NOTICE OF PUBLIC MEETING CITY OF MILLERSBURG PLANNING COMMISSION

Tuesday, March 20, 2018
6:00 p.m.

Proposal: The applicant proposes to subdivide 11.49 gross acres into 35 residential single family lots ranging from 10,001 sq. ft. to 13,843 sq. ft. with one tract (Tract A) for water detention.

Based on the above findings of fact, and the conditions of approval, the proposed project satisfies the applicable criteria, staff recommends the Planning Commission approve Subdivision Application No. SD 18-01, Westwood Estates pursuant to the conditions of approval listed below.

**TENTATIVE PLAT
 SITE LAYOUT**

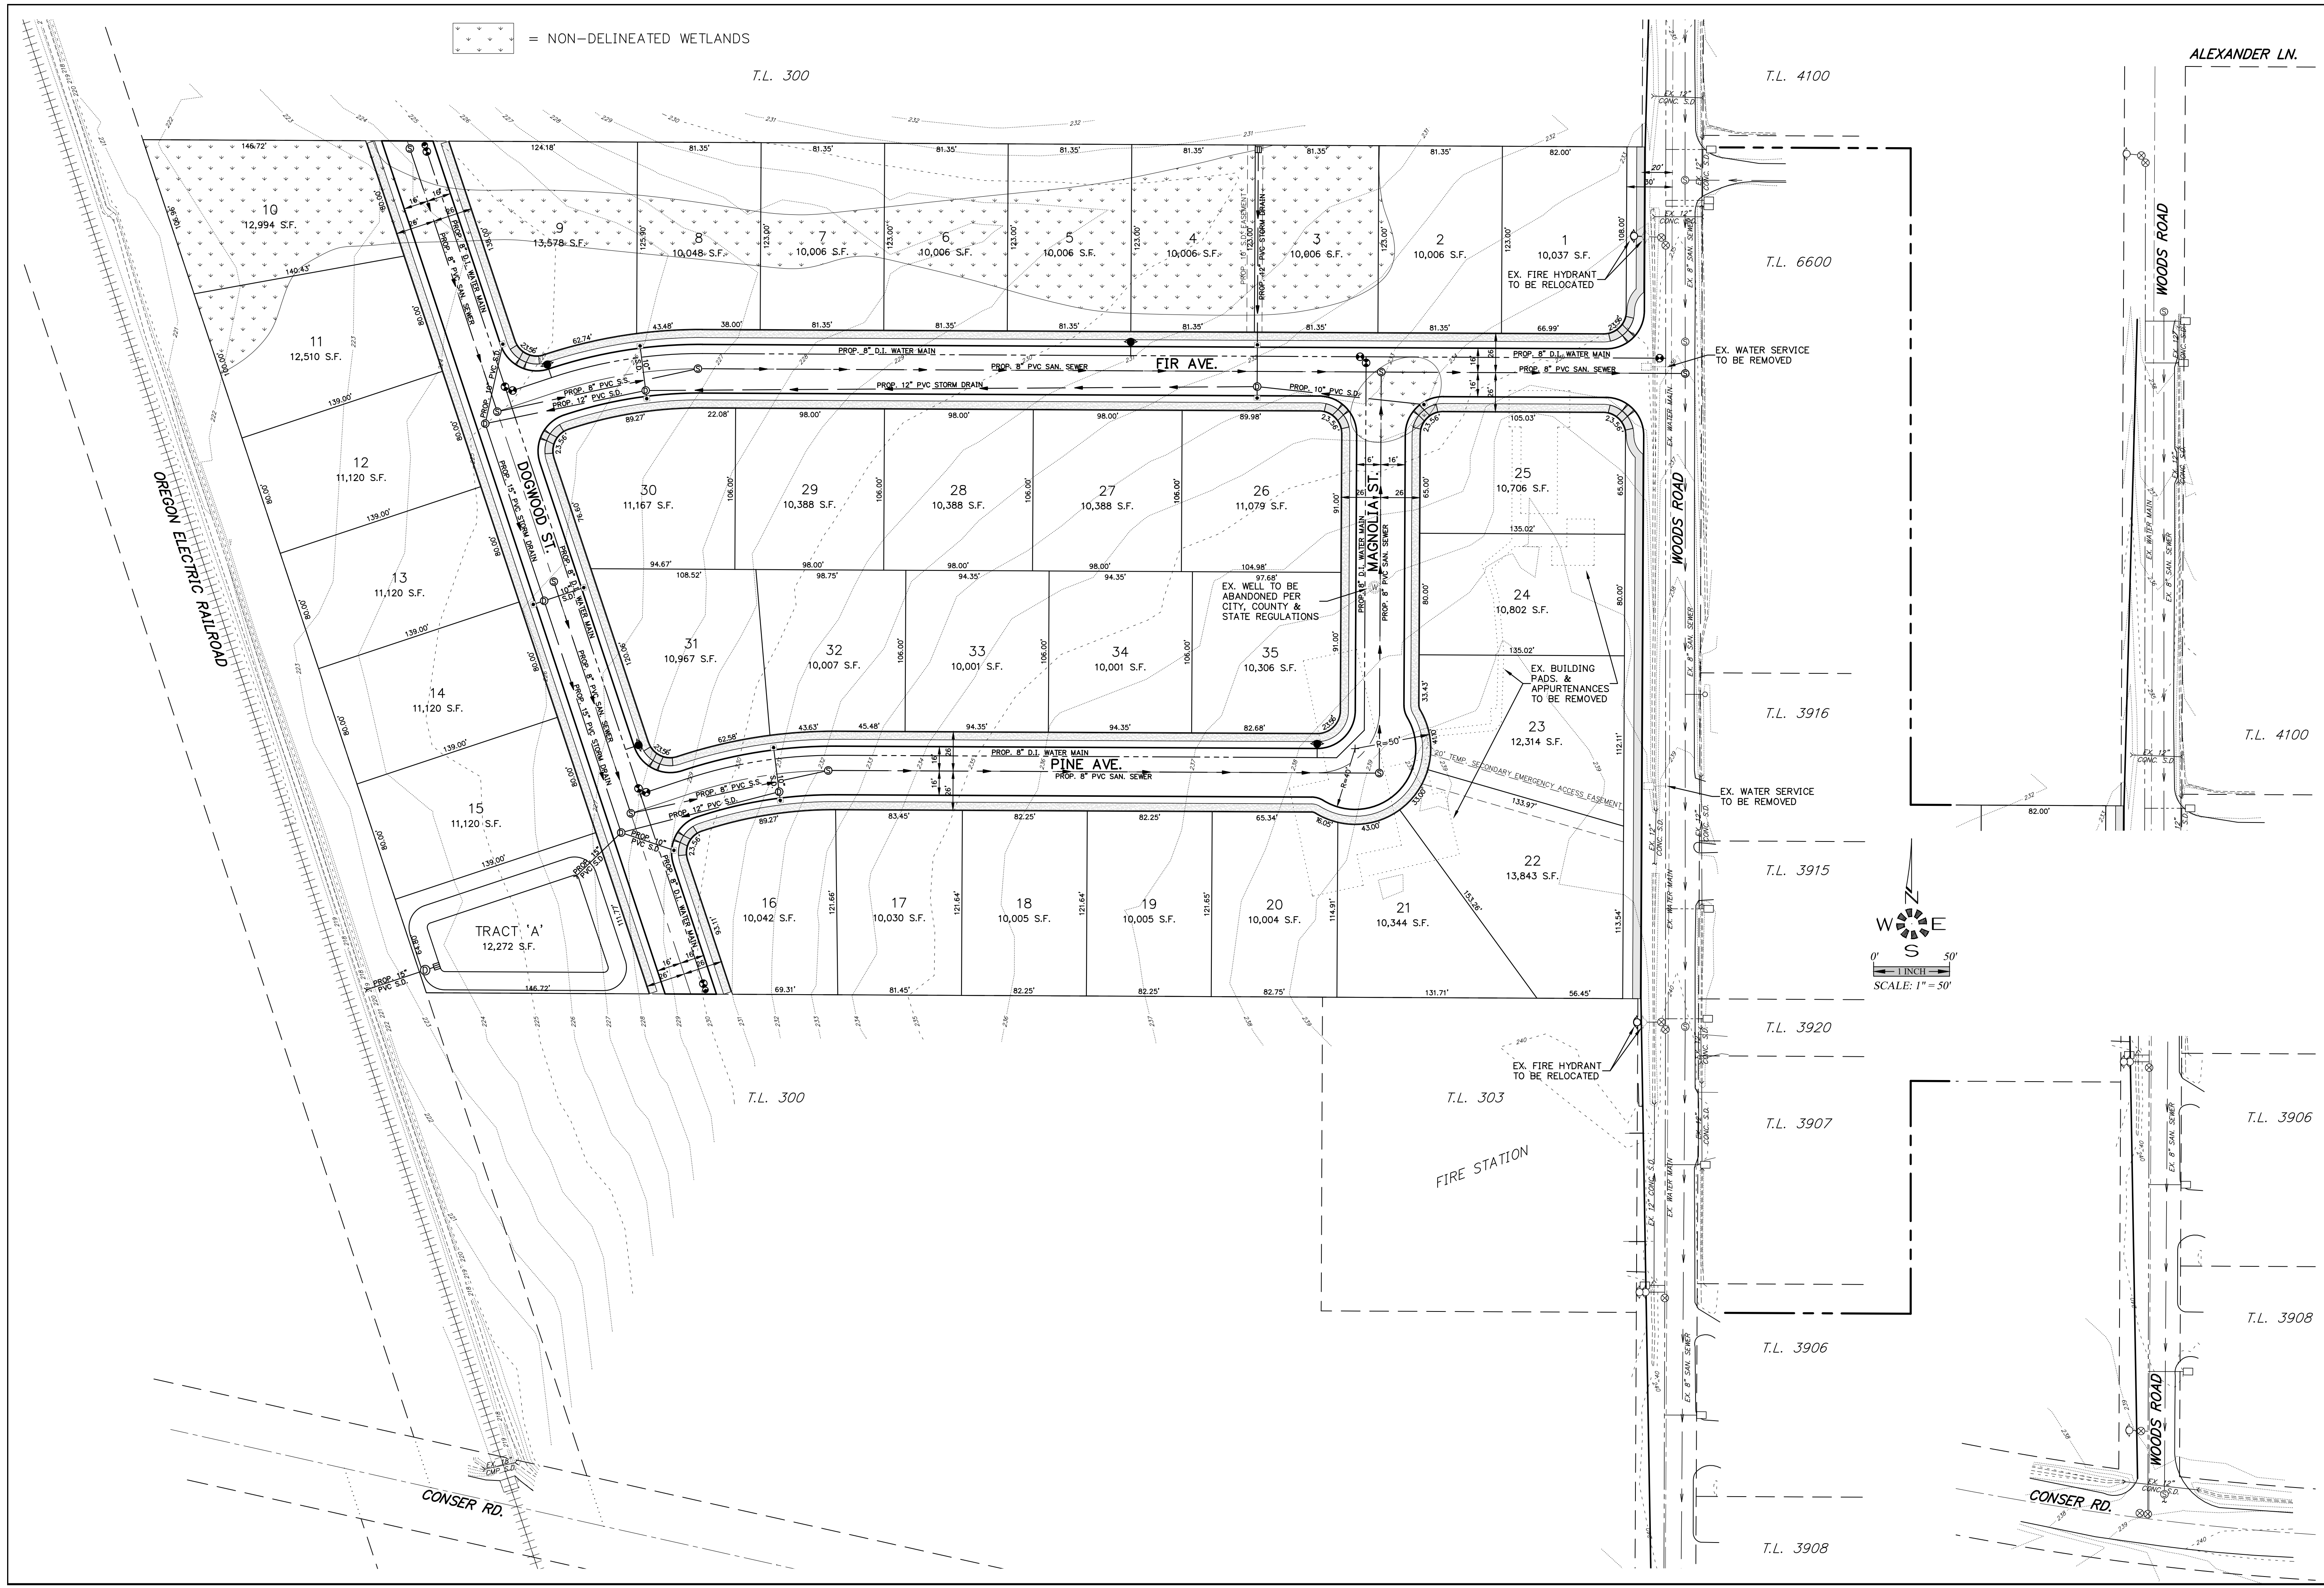
ANALYSIS: The streets proposed interior to the development are all shown to have full width build out. The project proposes to build only half-width improvements (plus 10 feet) along Woods Road NE. Conditions of approval have been added to assure the streets are constructed according to the design shown on the exhibits.

ANALYSIS: The plans show full sidewalks on both sides of all interior streets and the west side of Woods Road NE. All sidewalks are included in the street right of way. At this time there are no other sidewalks adjacent to the proposed subdivision, however, all sidewalks are designed to connect to future sidewalks when neighboring development is built out. All sidewalks are 5 feet in width with a planter strip between the residential lots and the streets. Sidewalks are also provided along Woods Road NE, however they are shown on the plans as curb adjacent. To conform with the code requirements, a proposed condition of approval has been added to revise all sidewalks on Woods Road NE to be separated from

the curb by 4 to 6 feet and a landscape strip to be added. Additionally, based on timing requirements a condition of approval has been added to specify that the sidewalks must be constructed at the time of home construction.

ANALYSIS: The design shown on the tentative map temporarily leaves only one point of access to the proposed subdivision, the one shown on Woods Road NE. Eventually there will be additional connection points to the north and the south of the subdivision. Until then, the single point of access for the proposed number of lots may present a safety issue for emergency access. As such the applicant shall provide an additional emergency point of access along Woods Road NE. An access point is shown on the tentative map that meets this requirement. A condition of approval has been added to specify design details of the access.

ANALYSIS: The project exhibits submitted by the applicant showed wetlands on the property within proposed lots 3-11. As such, the map was transmitted to the Department of State lands in accordance with the City requirements. Correspondence with DSL indicated that a wetland delineation was required. The applicant has since provided a delineation report to the City and the DSL. Additionally, as previously explained, DSL will require a Removal-fill permit issued by DSL prior to any ground disturbance activity. This is required by the State, however, a condition has been added requiring the applicant to provide any approved permit to the City for the files.

9. The applicant shall revise the location of the sidewalks along Woods Road NE to be separated from the curb by 4 to 6 feet and a landscape strip to be added.

12. Design partial street improvements for Woods Road NE frontage. Designs for partial street improvements shall consider the entire future street improvement so that related facilities, grades, slopes, utility stub-outs, future curb inlets, future service lines, potential conflicts, and other issues will be identified. The partial street shall be designed so that future completion of the street and related facilities can be easily coordinated with the initial partial street improvement and minimize damage to the street structure. Construction plans shall clearly show the paving limits for the partial street and identify all items that are to be constructed by others in the future. Partial street improvements shall include the western half of Woods Road NE to the road centerline, plus an additional ten feet of new asphalt pavement to the west of the road centerline. The road centerline is defined as the centerline of the existing 40' right-of-way.
